5. Quartz Creek Subdivision Wilkes Addition; KPB File 2024-053 Edge Survey & Design, LLC / Wilkes Location: Sterling Highway & Persistent Way Cooper Landing Area / Cooper Landing APC

ITEM #5 - PRELIMINARY PLAT QUARTZ CREEK SUBDIVISION WILKES ADDITION

KPB File No.	2024-053
Plat Committee Meeting:	June 10, 2024
Applicant / Owner:	Onie Ray Wilkes / Cooper Landing, AK
Surveyor:	Jason Young / Edge Surveying and Design, LLC
General Location:	Sterling Highway, Persistent Way, Cooper Landing, Cooper Landing APC

QUARTZ CREEK SUBDIVISION WILKES ADDITION

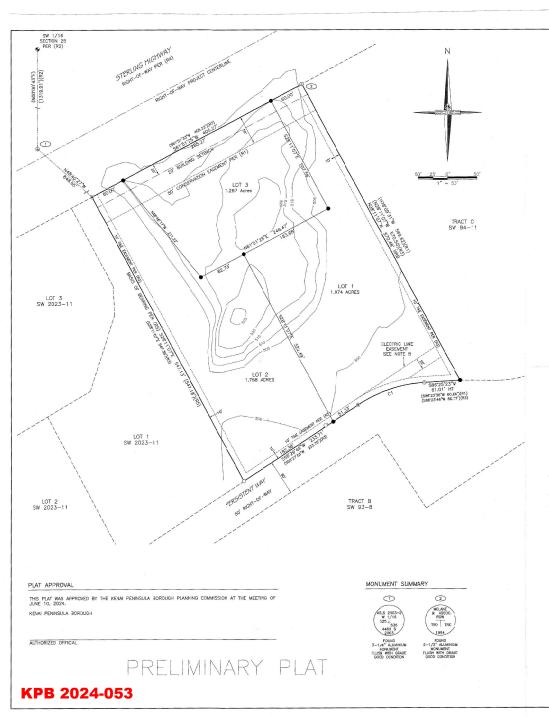
There are steep areas indicated by the contours shown on the drawing but they are not called out. **Staff recommends** prior to submittal of the final plat the contours be removed and the steep areas over 20% be noted on the drawing.

The property is subject to a 50 foot conservation easement abutting the Sterling Highway. The plat shows the required 20 foot setback which will be within the conservation easement. **Staff recommends** the setback remain in case the 50 foot conservation easement was ever terminated but at this time the terms of the conservation easement take precedent to the allowed uses of a setback as defined in KPB Code. The conservation easement along with a deed restriction were put into place by the Kenai Peninsula Borough prior to the parcel being sold. It appears some of the conservation easement may have been cleared. The status of the conservation easement will need to be verified and if any clearing or use is determined, staff will need to forward the information on to the KPB Code Compliance Officer to determine if the terms of the proposed plat are compliant. **Staff recommends** the surveyor verify if any portion of the 50 foot conservation easement has been cleared or has been used.

There appears to be a possible encroachment in the southwest corner of the property from the neighboring property. The surveyor was contacted about the issue and it was confirmed that there is no issue and the apparent items are wood piles and construction materials piles that will be moved.

HEA	This subdivision is not located within HEA's service area. No comments.
ENSTAR	ENSTAR Natural Gas Company has reviewed the following preliminary plat and has no
	comments of recommendations.
ACS	
GCI	Approved as shown.
CHUGACH ELECTRIC	Add 20' T & E Easement beyond the 50' Conservation Easement. Approved as corrected.

Change the KPB to 2024-053 Add OA to the front overall distance Steep slopes (20-80%) need shown on drawing. Plat Note #7, remove the second "-0" in the third line serial notation.

- Change the KPB to 2024-053
- The parent subdivision complete name is: Quartz Creek Subdivision <u>James Addition</u>, please correct accordingly.
- Add Alaska after the Seward Recording District in the legal description.
- 'Seward Recording District' is not needed in the lower legal description above the owner's portion and change "owners" to owner.
- C. The location, width, and name of existing or platted streets and public ways, railroad rights-of-way, and other important features such as section lines or political subdivisions or municipal corporation boundaries abutting the subdivision;

Add Right-of-way Varies to the large area of Persistent Way ROW.

Steep slopes (20-80%) need shown on drawing.

Possible encroachment in southwest corner of plat need verification from surveyor

Chugach Electric wants a 20' T & E easement added behind 50' Conservation easement.
